Re: *Petition by WISCAN, LLC for waiver of Rule 25-6.049(5), Florida Administrative Code; Docket No. 150142*

**DUKE ENERGY FLORIDA, INC.'S RESPONSE TO
STAFF'S FIRST DATA REQUEST (NOS. 1-5)
DOCKET NO. 150142-WISCAN, LLC' S PETITION FOR WAIVER OF
RULE 25-6.049(5), F.A.C**

Duke Energy - Florida Region		PRE-JOB SAFETY BRIEFING REQUIRED BEFORE STARTING WORK		
DRAWN BY: Marsden, Albert	BREAKER: UPSTREAM PROTECTION DEVICE	WORK REQUEST: 1019061	SHEET	
DATE: 	TAXING AUTHORITY: 	OPERATION CENTER: 	1	
JOB TYPE: 	S-T-R: 	TA: AP22 LAT LONG: 	OF 1

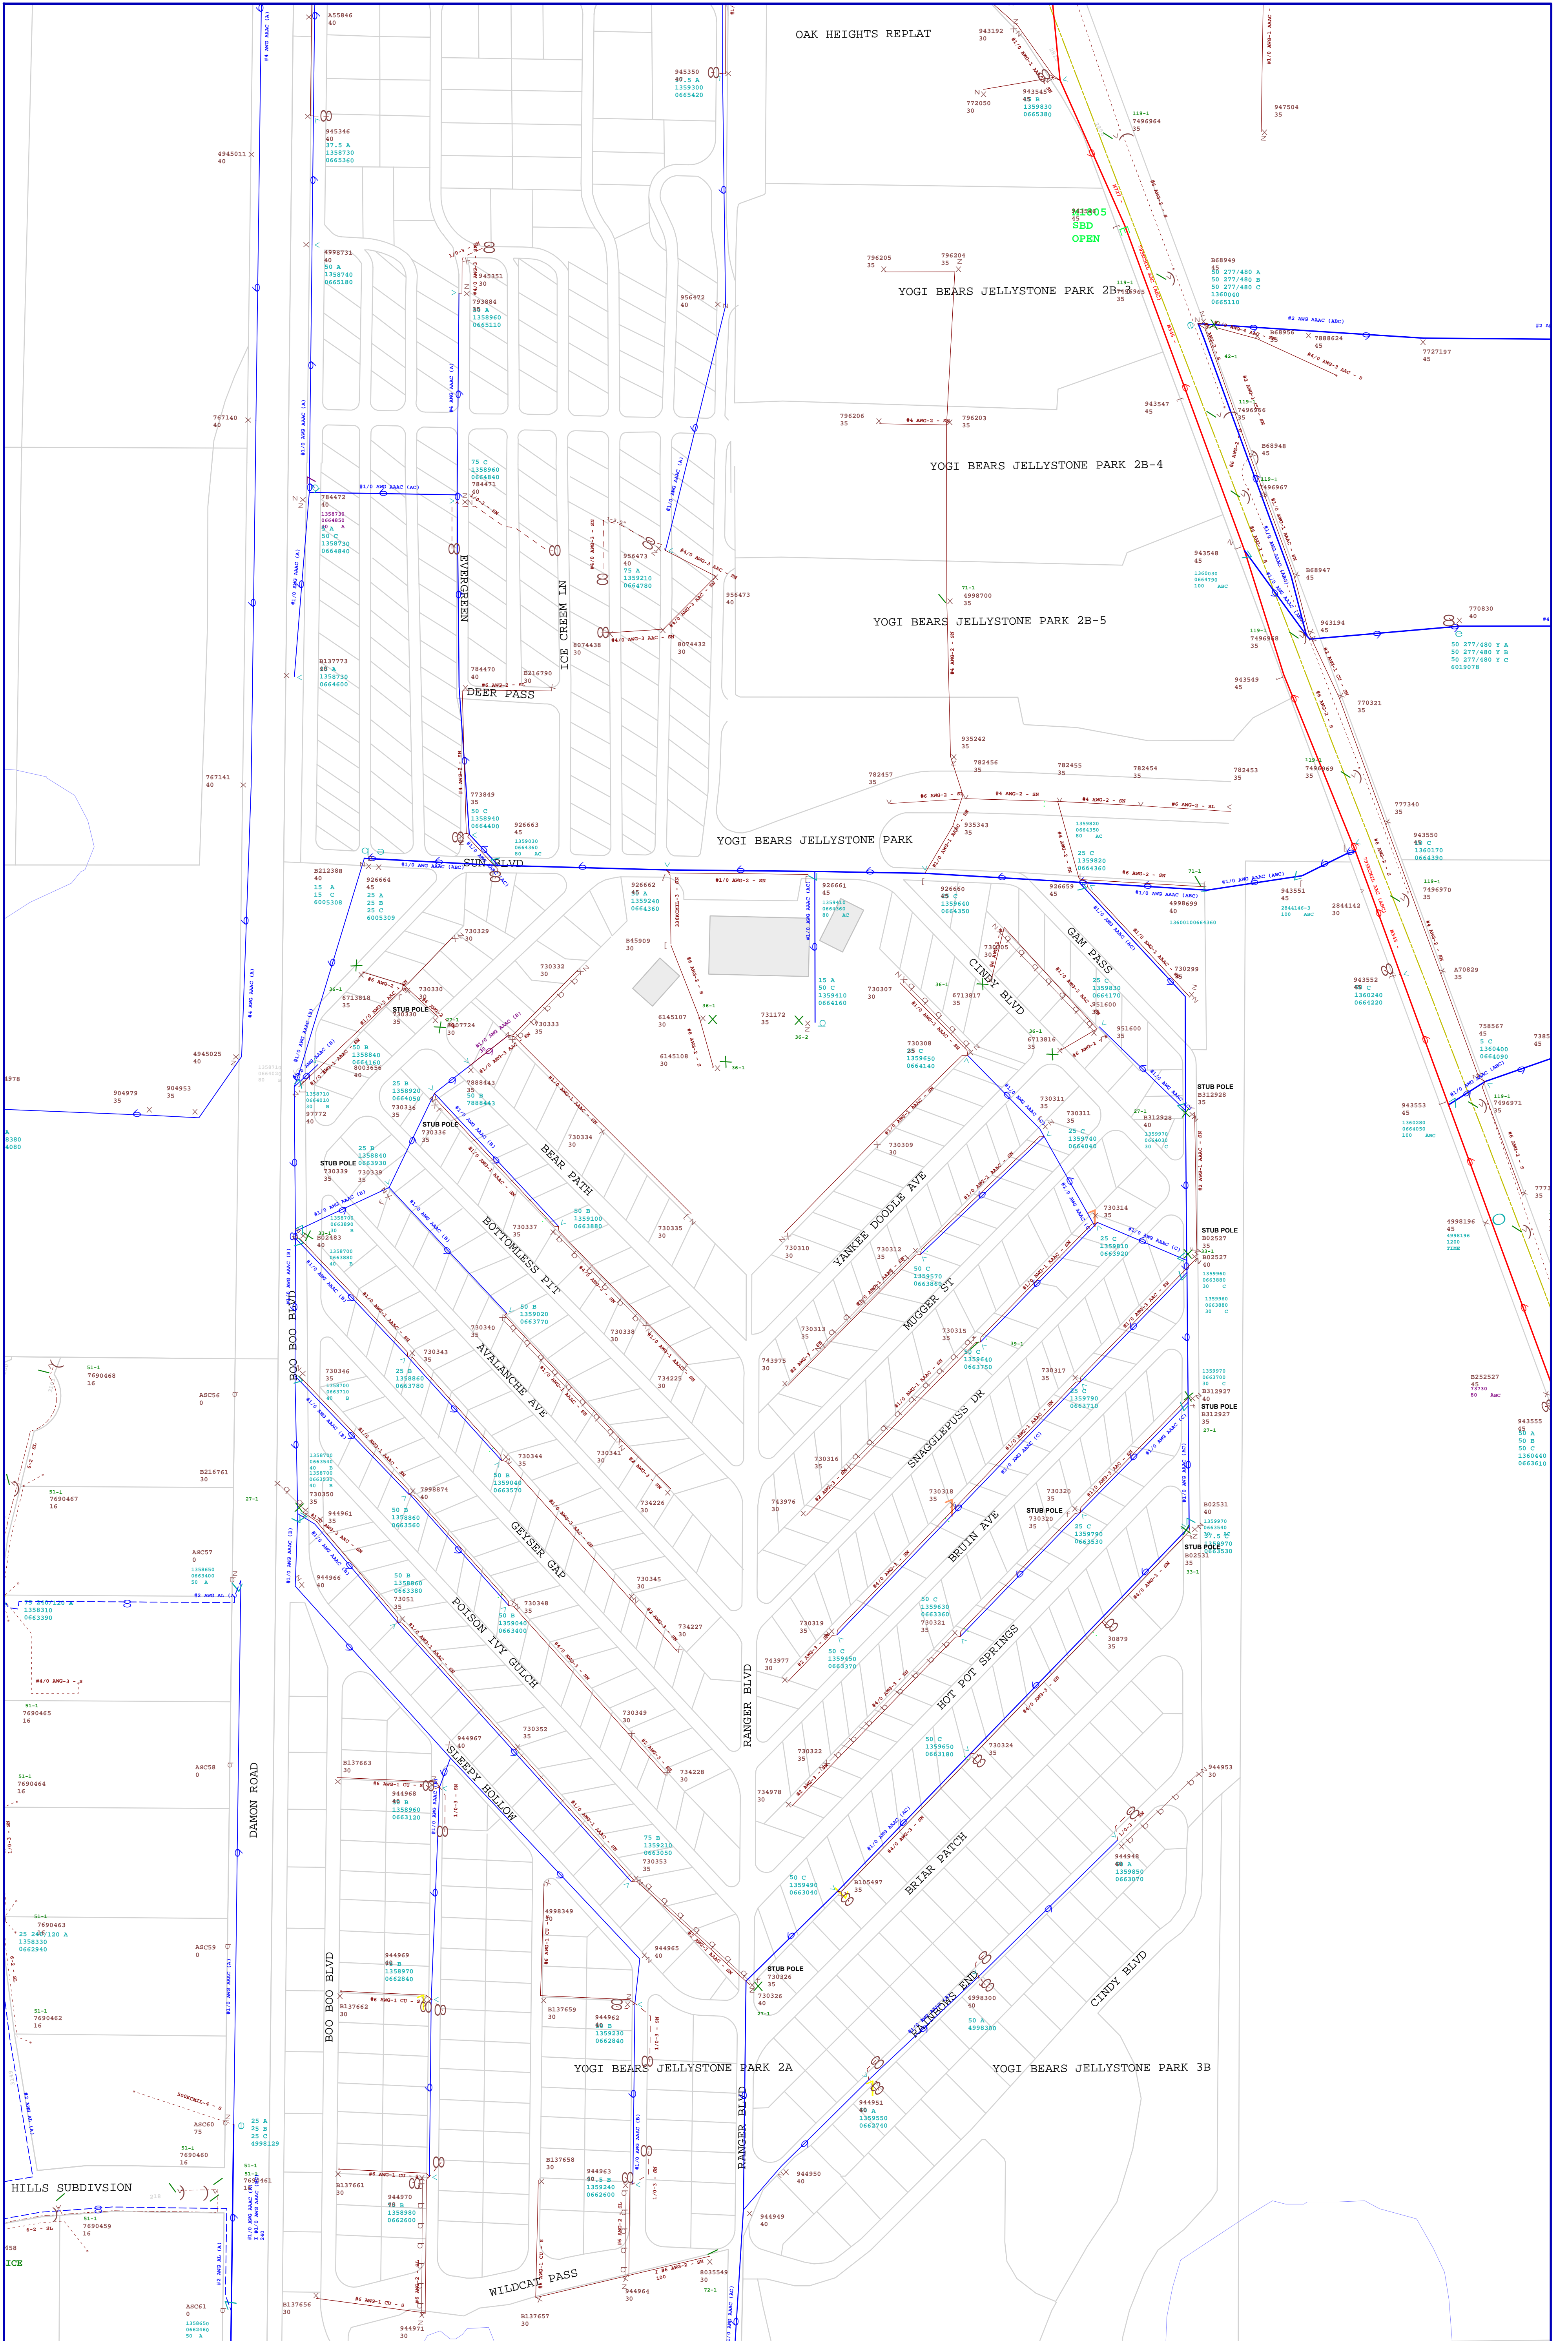
1. Please provide appropriate 'blue-lines,' drawings, or diagrams that show all existing DEF facilities that either have historically served or currently serve the landlocked store and adjacent areas of the Clarcona community.

4. When considering the DEF infrastructure in the vicinity of the Clarcona community holistically, is there any potential alternative facility configuration that could allow the landlocked store to receive new overhead service? If not, please provide a discussion of the reasons why overhead service is not possible.

Please see the attached.

Yes, DEF could partially design an overhead solution. However, this potential solution would require that some facilities be installed underground to meet clearances to avoid the bisecting and crossing of the existing facilities.

The potential new overhead service configuration would require the installation of 4 poles and spans of single phase overhead primary for approximately 530 feet, a termination and bore of underground single phase primary for approximately 300 feet, and the installation of a new 25KVA single phase transformer. As stated in response to Question 4, this potential configuration does not involve just overhead facilities. The estimated cost for this work is \$20,000. DEF notes that, in developing
